LISTING OF CHANGES TO DRB APPROVED SITE PLAN DATED 02-15-01

ADMINISTRATIVE 1000937
 DEVELOPMENT PLAN AMENDMENT
 FILE NO. AA-03AM-01290
 Meeting SDP: 29.07; 11/14/03
 Scheduling: Day Red, Land, R.O.
 Planning Director DATE

**CITY OF ALBUQUERQUE
 CAPITAL IMPLEMENTATION PROGRAM**

TITLE: W.S.T.F. REVISED SITE PLAN

1 REVISED SITE PLAN (07-01-03)
SCALE: 1/80" = 1'-0"

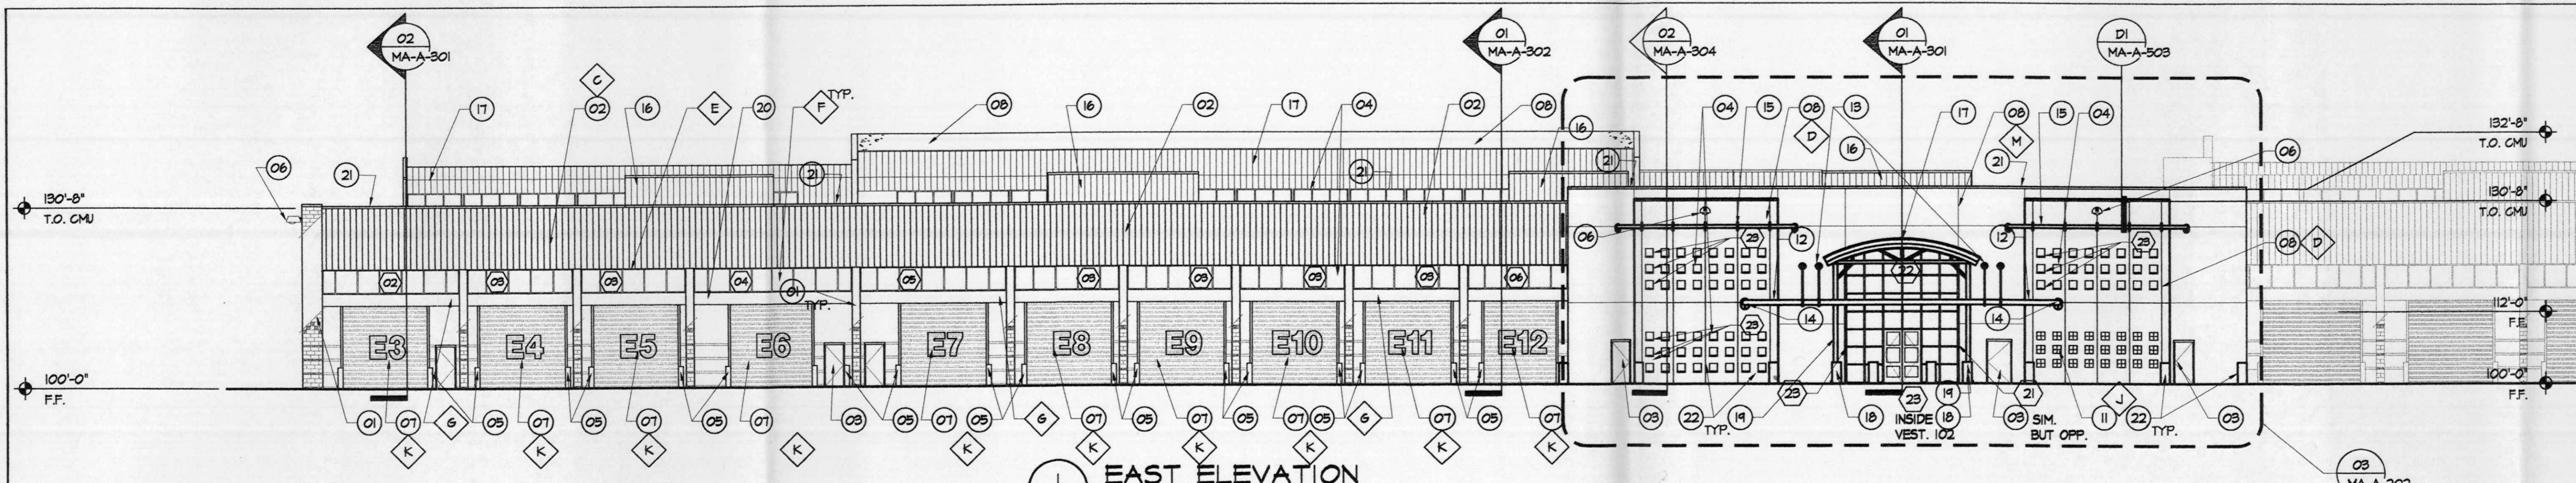
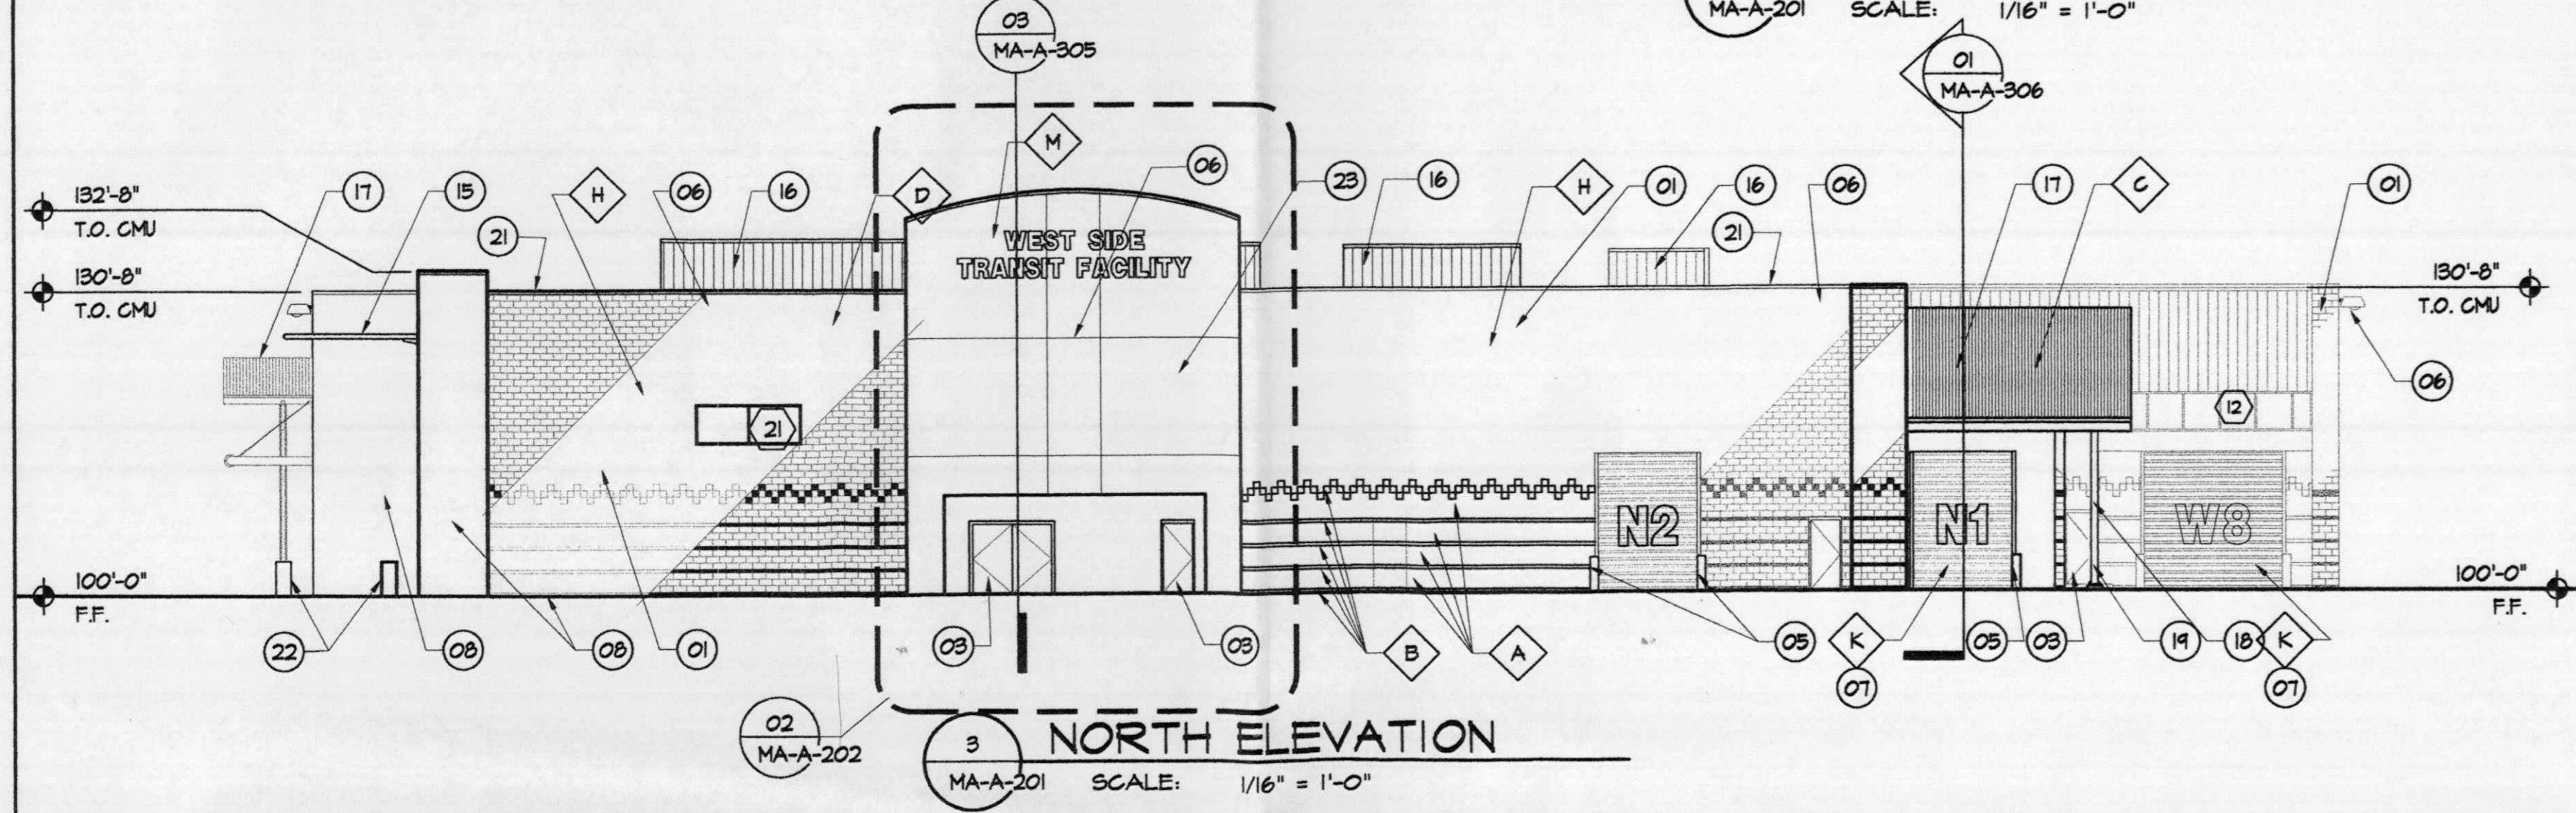
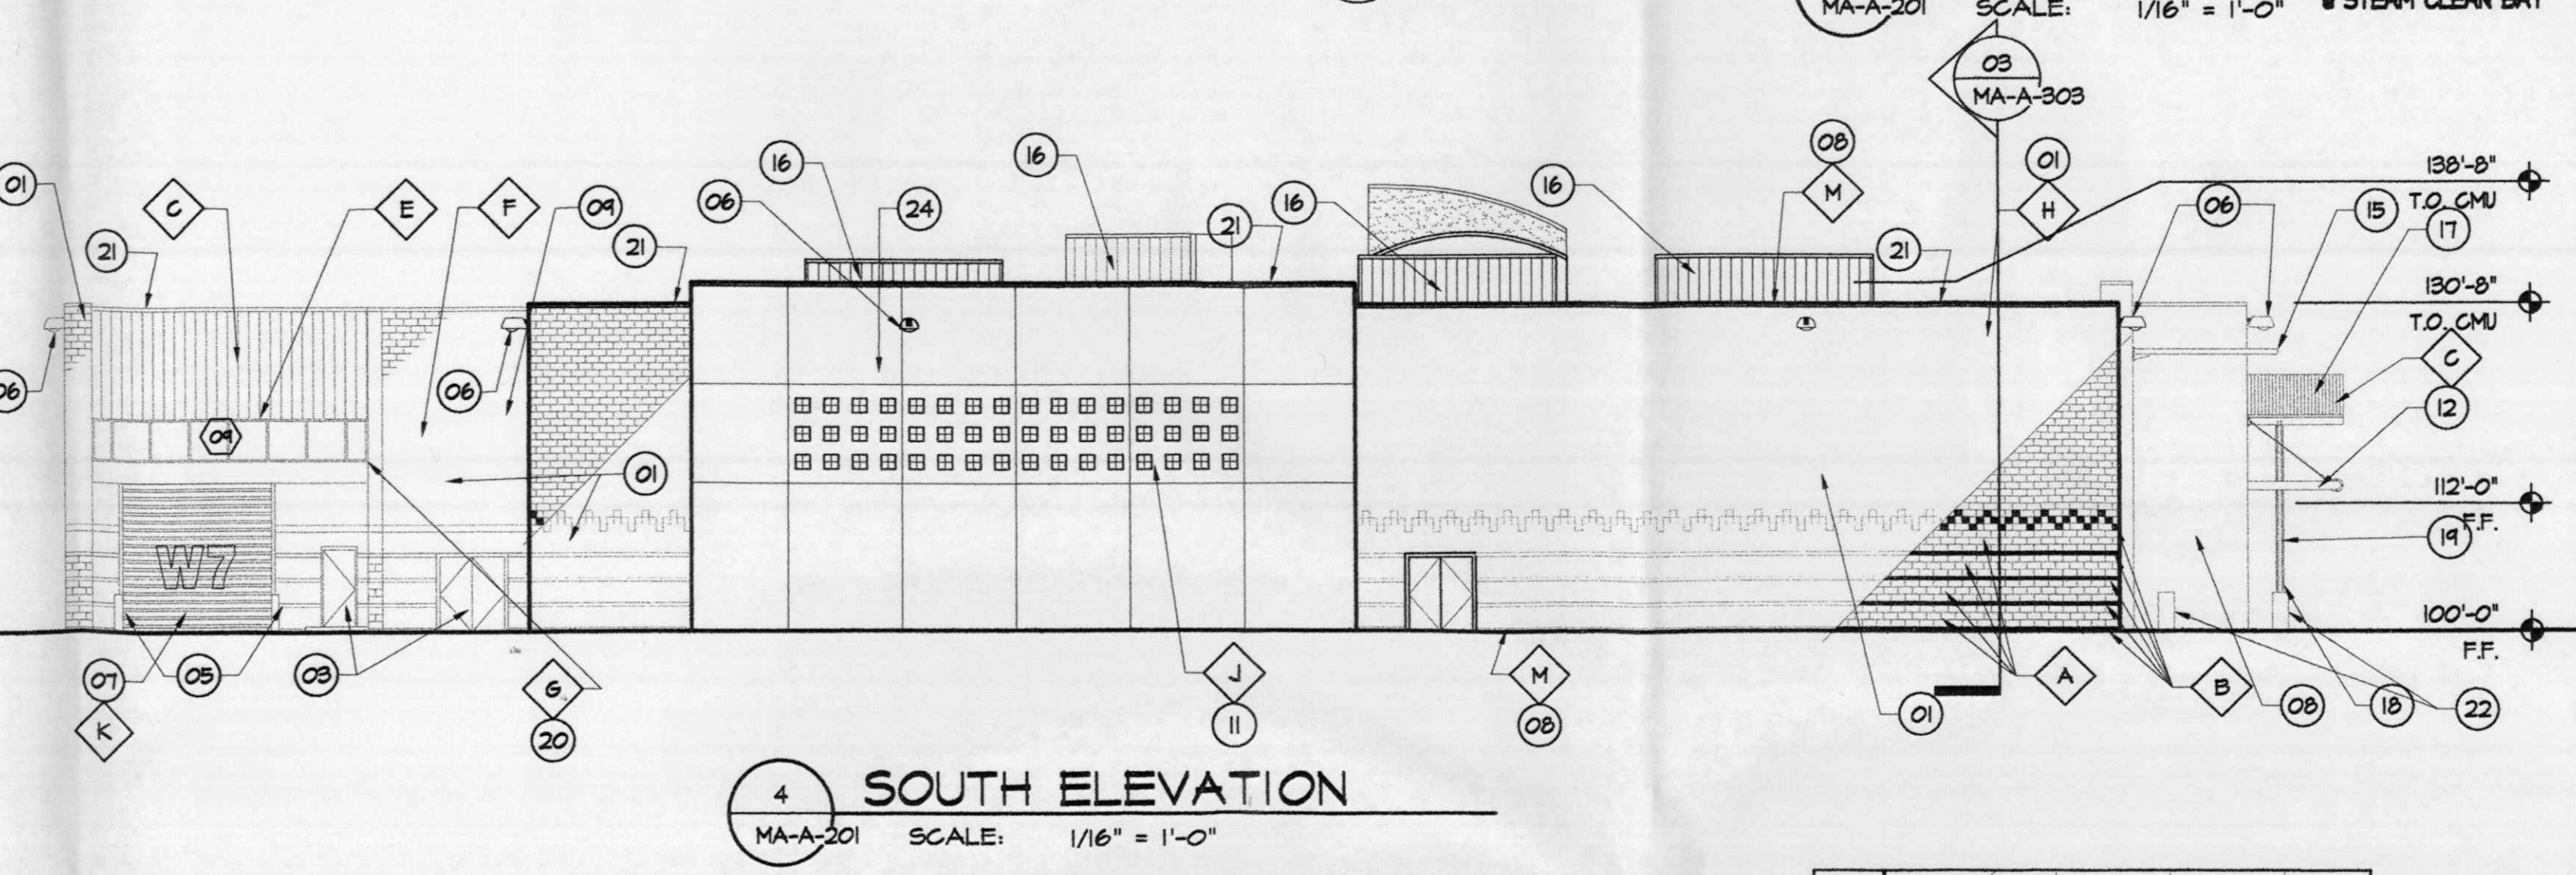
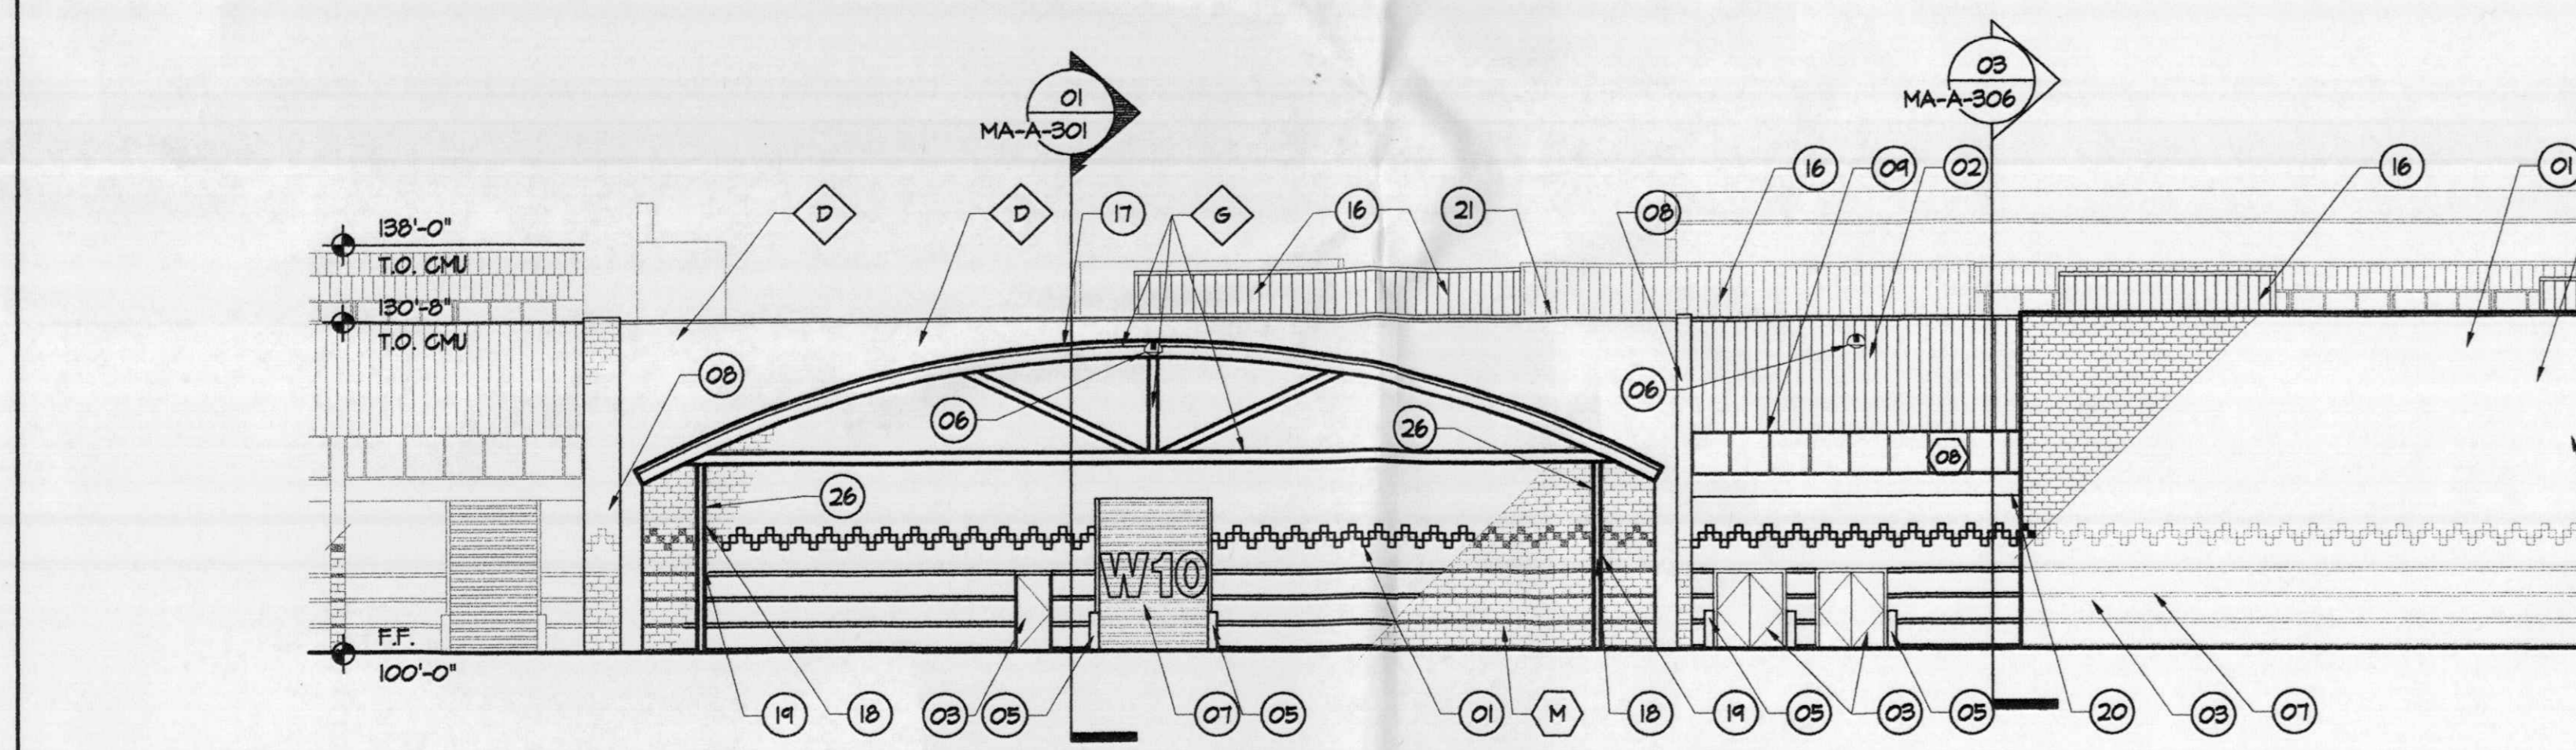
- * RETAINING WALL SHIFTED TO WEST 28'-2".
- * MAINTAINANCE BLDG. SHIFTED TO WEST 32'-11" & TO SOUTH 11'-0". ADDED 10,448 S.F.
- * OPERATION BLDG. SHIFTED TO WEST 93'-9" & TO SOUTH 10'-0". ADDED 1,329 S.F.

- * BUS STORAGE BLDG. SHIFTED TO WEST 12'-5" & TO SOUTH 20'-4". REDUCED IN LENGTH 71'-4". REDUCED IN SIZE 12,956 S.F.
- * WASH BLDG. REMAINED AT ORIGINAL LOCATION BUT ADDED ON FUTURE BAY ON SOUTH SIDE. MAKE PROVISION FOR WATER CONSERVATION & BOILER ROOM ADDITION ON NORTH SIDE.

- * FUELING BLDG. REMAINED IN ORIGINAL LOCATION BUT ADDED FUTURE BAY ON SOUTH SIDE.
- * CONTROL BLDG. SHIFTED TO SOUTH 61'-9". NO CHANGE IN SIZE.
- * CHANGED PARKING S.E. OF OPERATION BLDG. TO DOUBLE LANE OF DIAGONAL PARKING & SHIFTED LOCATION TO WEST 93'-9".

- * DAY CARE BLDG. IS SAME AS ORIGINAL 9500 S.F.
- * REDUCED SIZE OF OUTDOOR ACTIVITY AREA FROM 11325 S.F. TO 9099 S.F. (EXCEEDS DAY CARE REQUIREMENTS)
- * REDUCED ADJACENT DAY CARE PARKING DROP OFF FROM 22 SPACES TO 8 SPACES. (DAY CARE STAFF PARKING MAY BE ACCOMMODATED IN PARKING S.E. OF OPERATION AND/OR STAFF PARKING.)

- * ADDED FUTURE VAN STORAGE BLDG. LOCATION. (SIZE TO BE DETERMINED AT FUTURE DATE)
- * STAFF PARKING REDUCED FROM 342 TO 294 (3 SHIFTS OF STAFF PARKING WAS ERRONEOUSLY ADDED TOGETHER RATHER THAN 2 FOR OVERLAP OF PARKING)
